Re: Comments on the 2015 Tennessee Valley Authority Integrated Resource Plan Supplemental Environmental Impact Statement

**Figure 2. 4,000 MW of Utility-Scale Solar
Hypothetical Landscape Impact on Western Portion of TVA Service Territory**

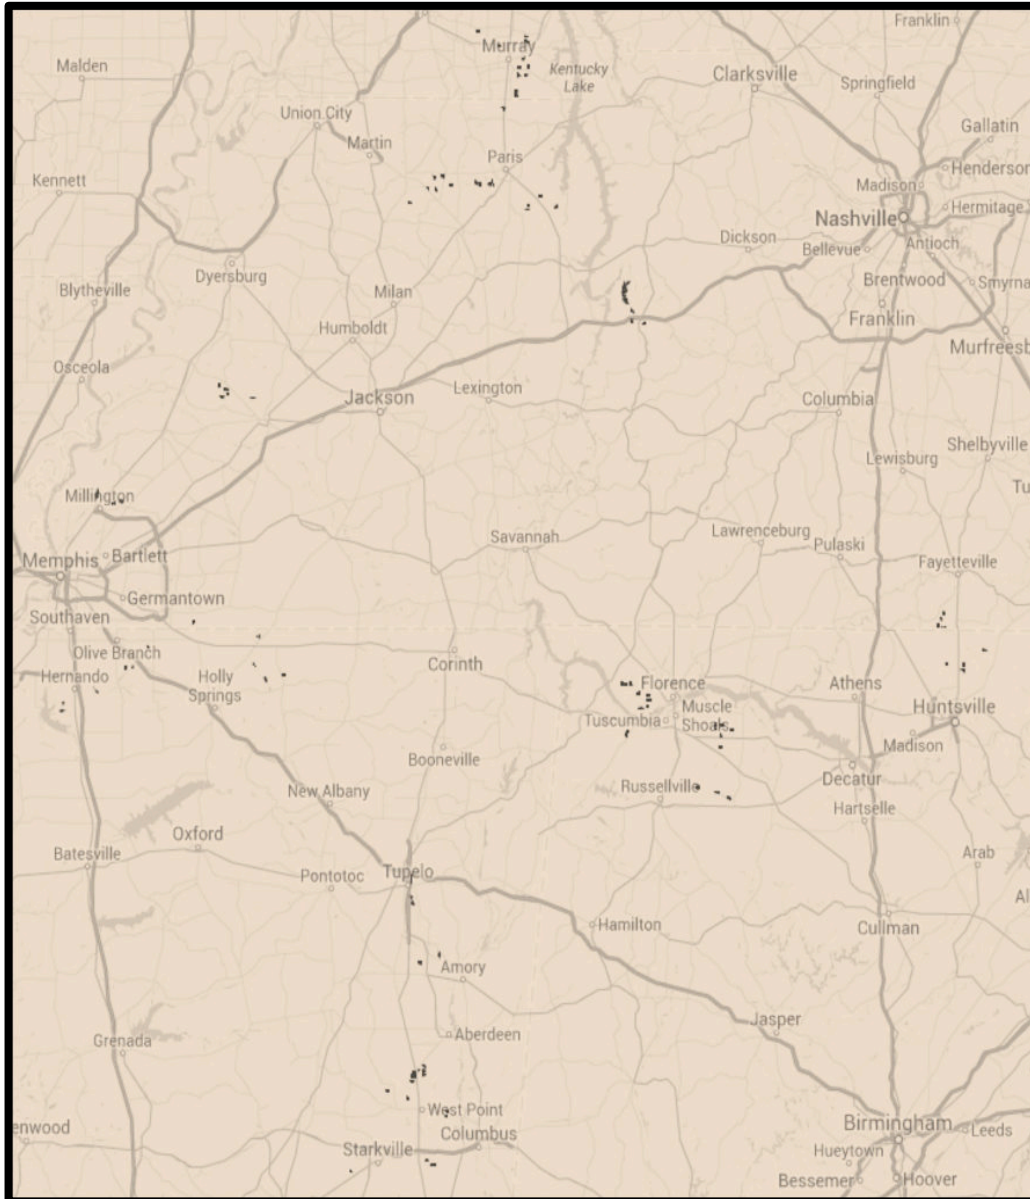
We urge TVA to place the impacts of solar PV facilities at large scale in context of the region. Based on industry averages, if TVA built 4,000 MW of utility-scale solar without any rooftop installations, we estimate roughly 50 square miles of solar facility ground cover. In Figure 2, SACE has provided a map illustrating the actual land area impacted by a potential distribution of 4,000 MW of utility-scale solar concentrated entirely in the western portion of TVA's service territory. The red shapes (generally appearing as dots which may be difficult to distinguish) represent various solar farms located in a hypothetical development array. As Figure 2 makes evident, while 50 square miles may appear to be a large number, it is less than 0.1% of TVA's service area and would represent a much less consequential impact on the landscape that, for example, the interstate highway system.
